Form 3160-5
(June 2019)

SUNDRY NOTICES AND REPORTS ON WELLS
Do not use this form for proposals to drill or to re-enter an abandoned well. Use Form 3160-3 (APD) for such proposals.

8. Well Name and No. **JUPITER 30 FED COM/401H**

EOG respectfully requests an amendment to our approved APD for this well to reflect the following changes:

Revised Wellbore A:
 API: 30-025-52439

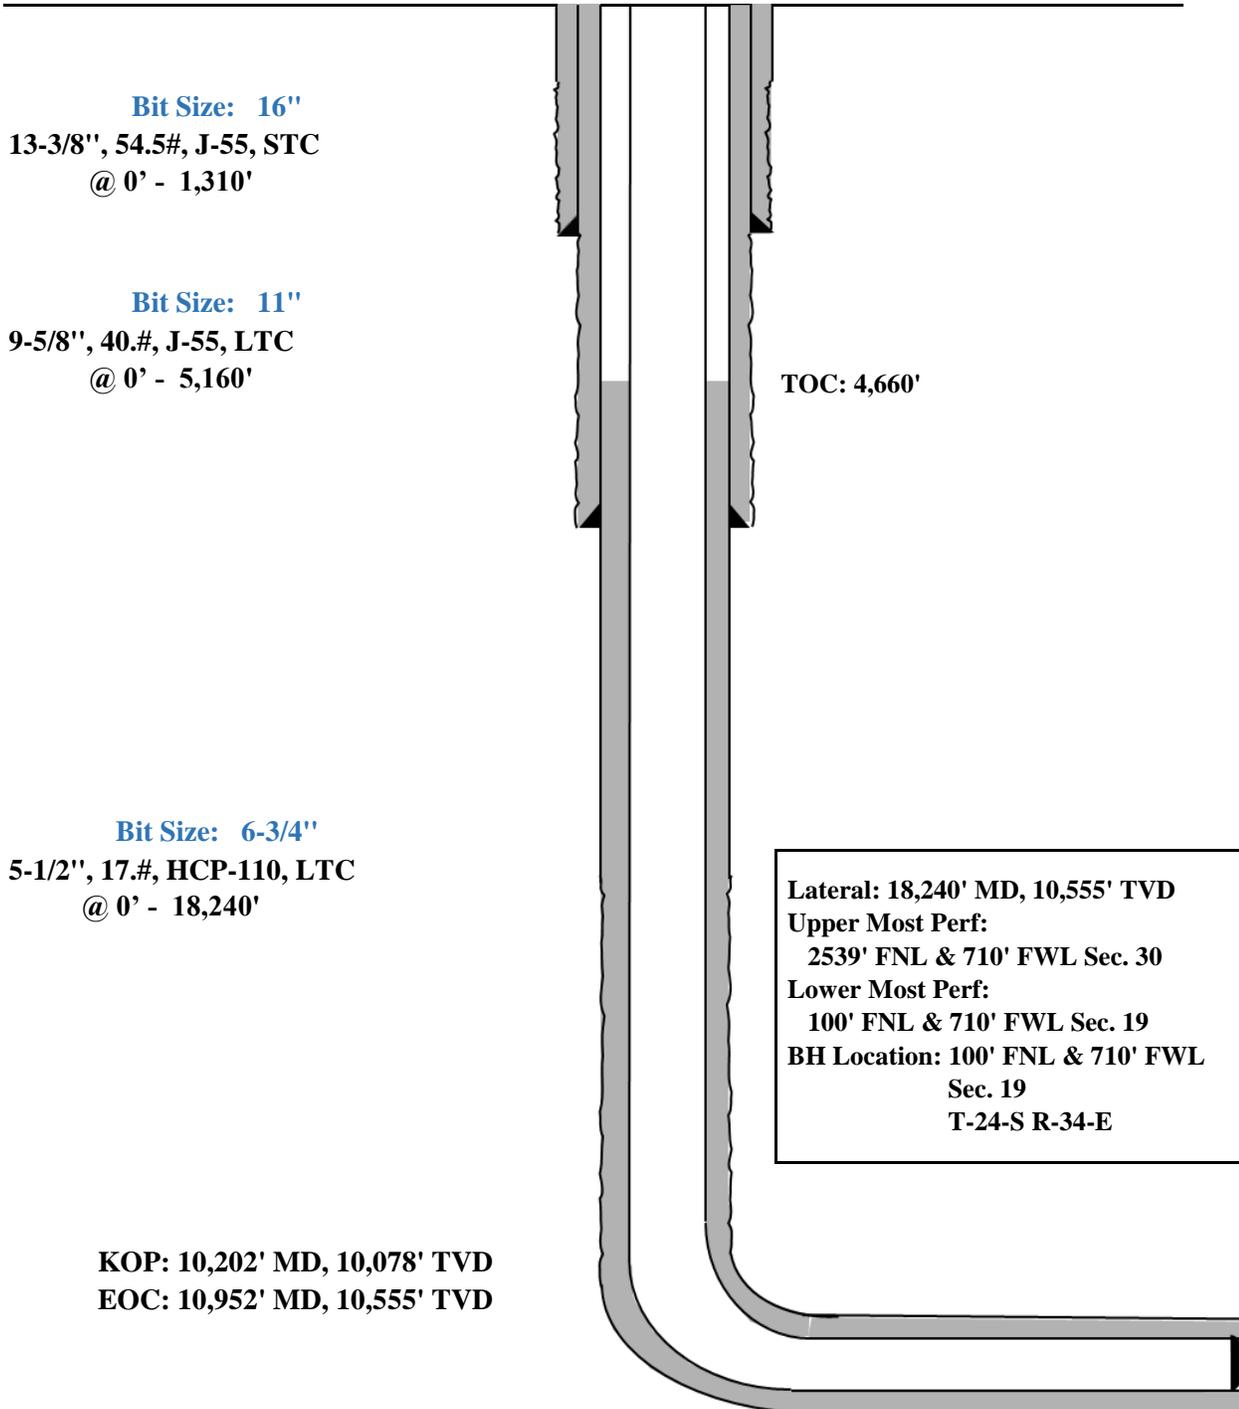
Change SHL from T-24-S, R-34-E, Sec 30, 2133' FNL, 1266' FWL, Lea Co., NM,
to T-24-S, R-34-E, Sec 30, 2133' FNL, 1806' FWL, Lea Co., N.M.

Casing Program A:

Variance is requested to waive the centralizer requirements for the 9-5/8" casing in the 11" hole size. An expansion additive will be utilized, in the cement slurry, for the entire length of the 11" hole interval to maximize cement bond and zonal isolation.

Variance is also requested to waive any centralizer requirements for the 5-1/2" casing in the 6-3/4" hole size. An expansion additive will be utilized, in the cement slurry, for the entire length of the 6-3/4" hole interval to maximize cement bond and zonal isolation.

EOG requests permission to allow deviation from the 0.422" annulus clearance requirement for the intermediate (salt) section from Onshore Order #2 under the following conditions:

Revised Wellbore B:

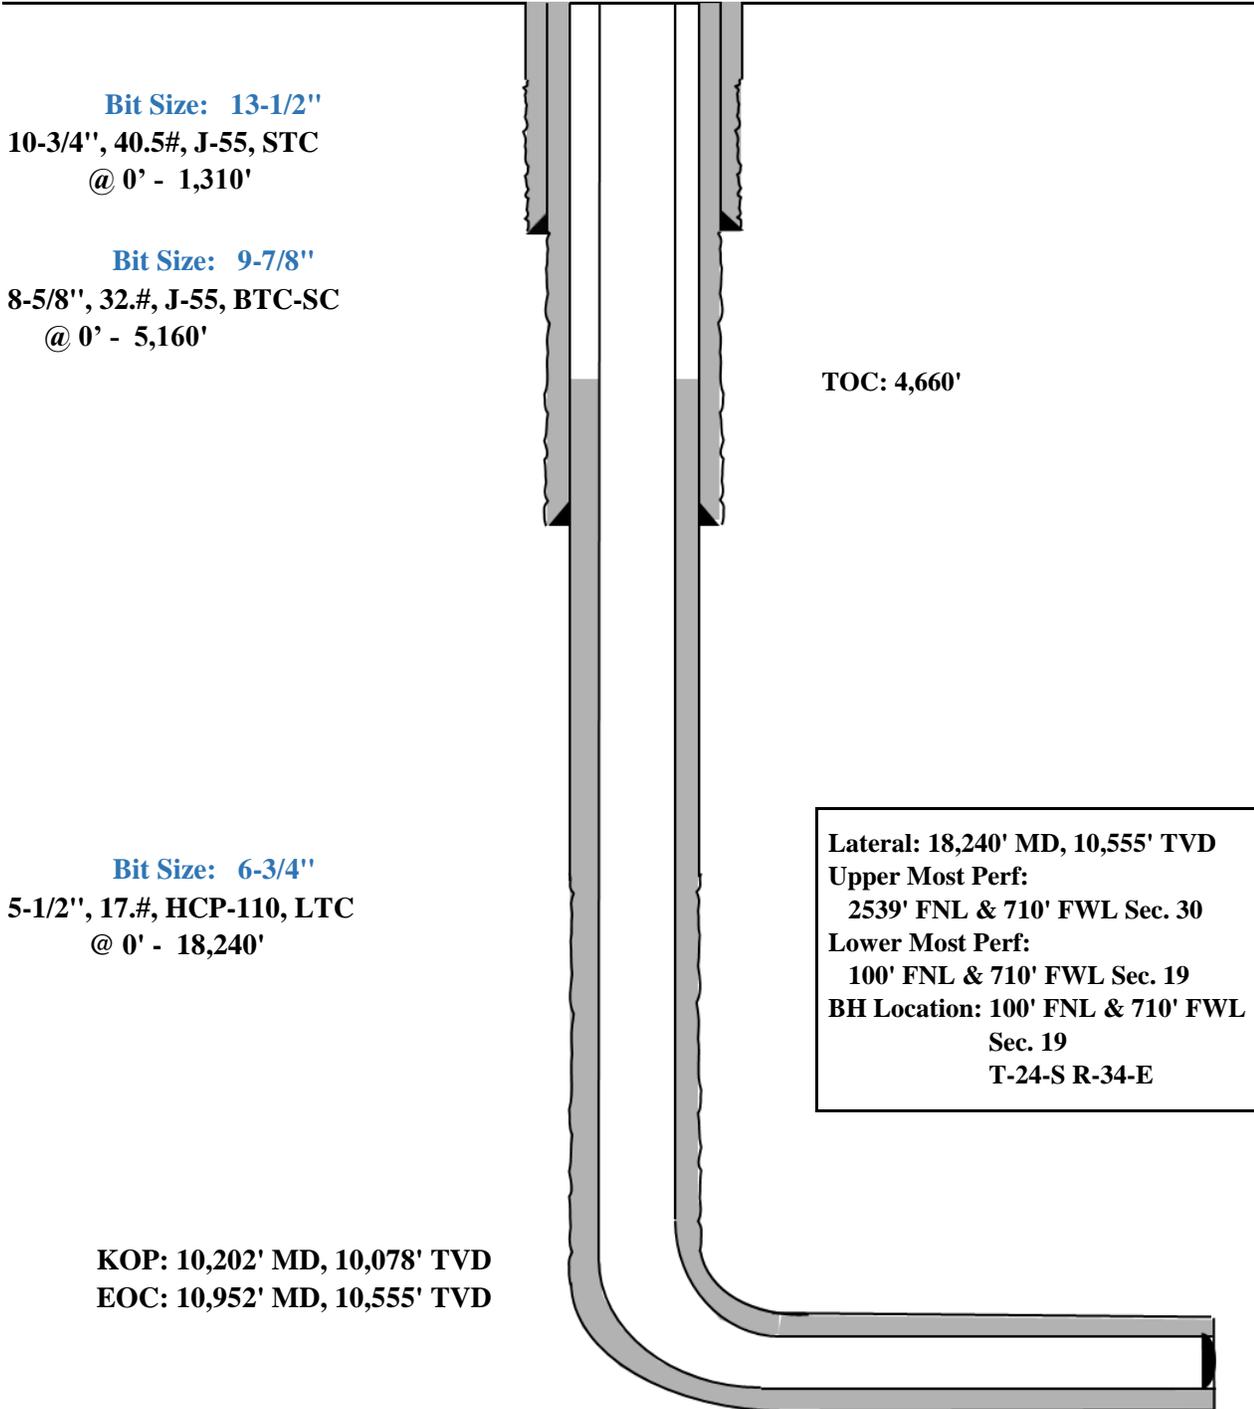
Casing Program B:

Variance is requested to waive the centralizer requirements for the 8-5/8" casing in the 9-7/8" hole size. An expansion additive will be utilized, in the cement slurry, for the entire length of the 9-7/8" hole interval to maximize cement bond and zonal isolation.

Variance is also requested to waive any centralizer requirements for the 5-1/2" casing in the 6-3/4" hole size. An expansion additive will be utilized, in the cement slurry, for the entire length of the 6-3/4" hole interval to maximize cement bond and zonal isolation.

EOG requests permission to allow deviation from the 0.422" annulus clearance requirement for the intermediate (salt) section from Onshore Order #2 under the following conditions:
